## DEVELOPMENT APPLICATION ASSESSMENT REPORT

<b>Application Number:</b>	DA2021/2262
----------------------------	-------------

<b>Responsible Officer:</b>	Anne-Marie Young
<b>Land to be developed (Address):</b>	Lot 1 DP 412086, 14 Ocean Road PALM BEACH NSW 2108
<b>Proposed Development:</b>	Demolition works and construction of a dwelling house including a swimming pool
<b>Zoning:</b>	C4 Environmental Living
<b>Development Permissible:</b>	Yes
<b>Existing Use Rights:</b>	No
<b>Consent Authority:</b>	Northern Beaches Council
<b>Delegation Level:</b>	DDP
<b>Land and Environment Court Action:</b>	No
<b>Owner:</b>	Asia Digital Investments Pty Ltd
<b>Applicant:</b>	Reform Projects Pty Ltd

**8.5m height plane diagram** (source Matieson)

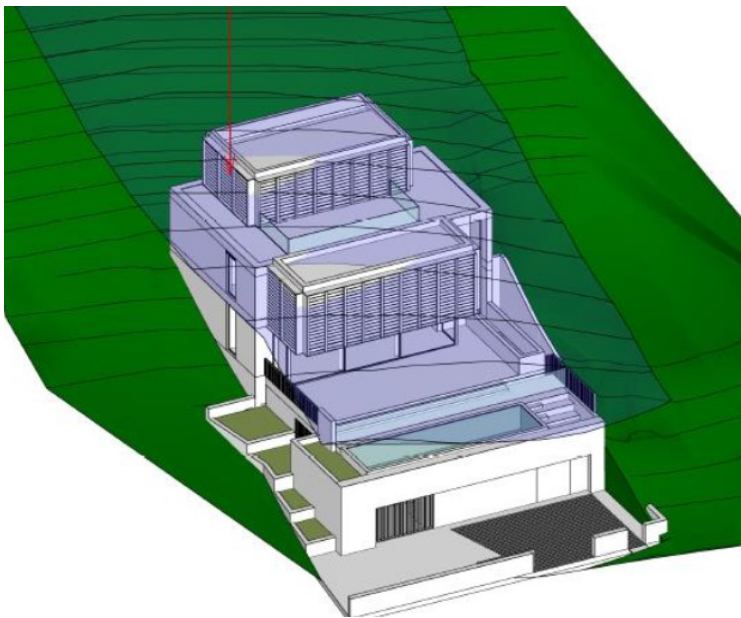
The height of the proposed dwelling house, as amended, has been measured at 9.71m above ground level.

Despite the 8.5m development standard that applies to the subject site, a maximum building height of 10.0m is permitted on this site, but only if the proposed development satisfies the relevant requirements of Clause 4.3 (2D) of PLEP 2014.

\*Note: The natural ground levels of the land have been modified to accommodate the existing dwelling. The applicant's height diagram interpolates the natural undisturbed ground level across the site.

In summary, the proposal, as amended, significantly reduces the extent of non-compliance with the 8.5m height standard through the provision of an increase setback to the southern boundary and pulling back the upper floor away from the street frontage. The breaching element is assessed as minor and meets the criteria for the 10.0m concessional building height limit for steeply sloping sites. The building steps down the site and is an appropriate response to the desired character of the Locality. As such, the proposal satisfies clause 4.3 2(D) and a Clause 4.6 Variation Statement is not required.

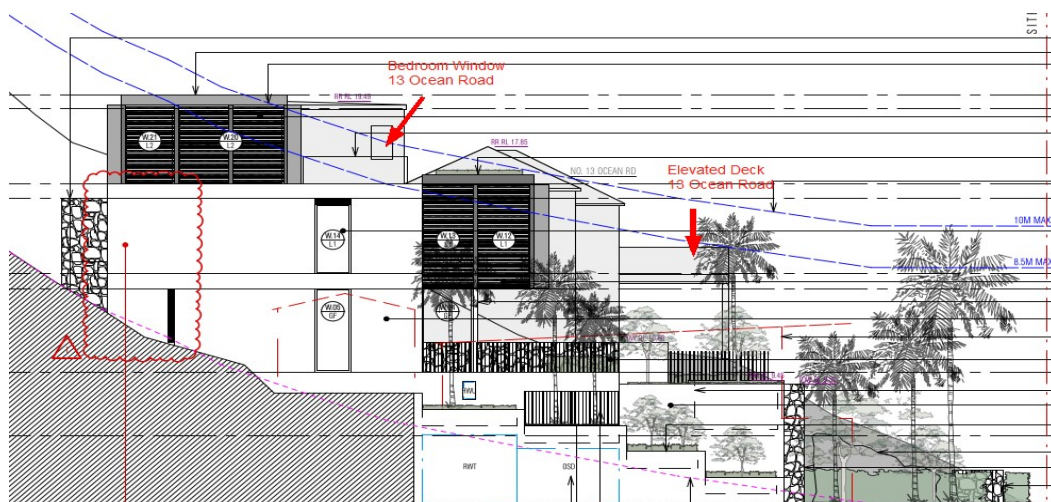
No. 13 Ocean Road sits back from the street frontage in an elevated position. The lower ground and ground floor of the proposed dwelling are setback a minimum of 7.4m from the frontage at a lower level to the ground and first floor of No. 13 Ocean Road to the immediate north. The lower levels of the proposed dwelling will not result in any adverse impacts on views to the southern or northern headland or eastern views to the Ocean.

Level 1 of the proposed dwelling is setback from No. 13 Ocean Road (approximately 5.6m to the west of the frontage of the elevated deck, 2.2m to the west of the frontage of the east facing window to the open plan living area and 0.9m from the recessed eastern wall). Given the setback of Level 1 behind the frontage of No. 13 Ocean Road, there will be no unreasonable view loss to the neighbouring property to the immediate north.

Concern has been raised regarding the impact on views enjoyed from the upper floor bedroom window looking across the side boundary of the subject site looking towards the south. The bedroom in question has a corner window to the frontage which has a primary view to the east to the ocean. There will be no unreasonable view loss from the east facing bedroom window. The eastern external wall of Level 2 of the proposed dwelling is setback approximately 2.2m from the edge of the south facing bedroom window. The window will overlook the terrace of the master-bedroom to the southern headland beyond. As such, it is not envisaged that there will be any unreasonable loss of view from the south facing bedroom window.

**View Analysis Plan** (source Mathieson Architects)

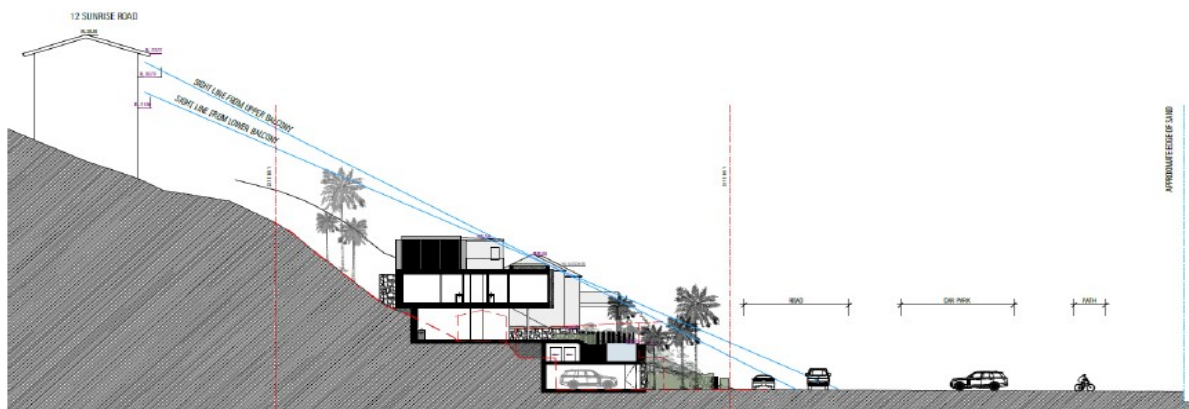
The applicant has submitted a View Analysis plan DA3(A) based on the available survey information which demonstrates that the proposed development will not obstruct the existing ocean views enjoyed from No. 12 Sunrise Road, refer to image below:

It is Council's assessment that there will be no unreasonable view loss impacts on No. 12 Sunrise Road located directly to the west (rear) given its elevated location. Eastern ocean views will be retained over the roof of the proposed dwelling. Given the above assessment and information submitted by the applicant in response to the view loss concern it is not considered reasonable to request that height poles in this instance.

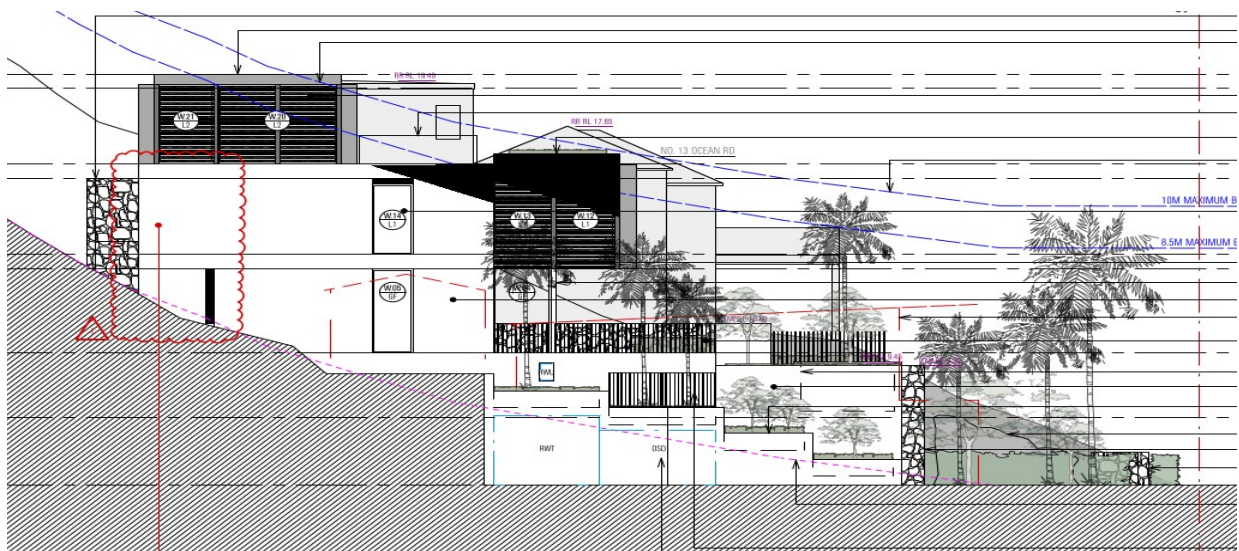
The external materials palette generally consists of dark earthy colours in compliance with the control. It is noted that some minor elements, including the southern external rendered masonry wall of the mid level (Level 1) is painted in a light colour. On merit, this is considered acceptable, as it is consistent

with light external colour scheme of the dwelling to the immediate south. The change in colour also helps break up the mass of the southern elevation.
